SERVICE BULLETIN

APPLICABILITY: 2018-2021MY Crosstrek 2.0L DI & PHEV
2017-2021MY Impreza 2.0L DI

NUMBER: 09-81-21

SUBJECT: Fuel Injector- Design Change
Misfire DTC P030* / Engine Knocking / DTC P219C-D-E-F

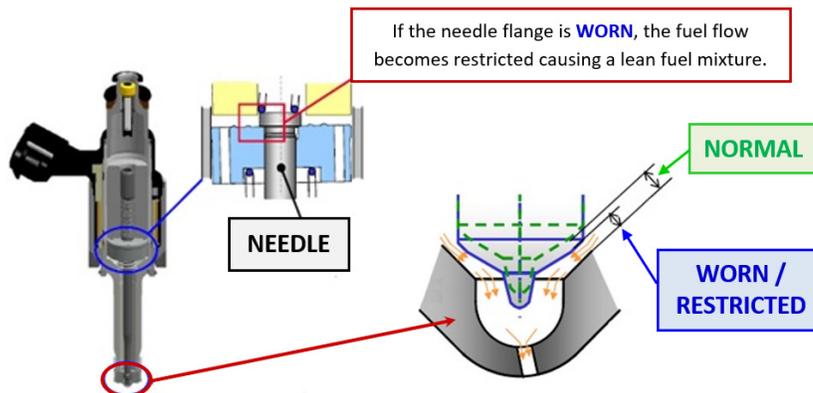
- Using the illustration below for identification reference, always replace an injector assembly with the same flow rate number as originally equipped.

STEP 8) Identify the injector assembly(s) by confirming the vendor part number and flow rate number engraved on the injector body as shown in the Parts Information section above. Replace the injector(s) as necessary with the **NEW** part(s) having the matching flow rate. Remove any carbon build-up found during replacement:
Engine > FUEL INJECTION (FUEL SYSTEMS) > Fuel Injector.

Injector Assembly Part Number	Flow Rate Number
16611AA971	"4"
16611AA981	"5"
16611AA991	"6"
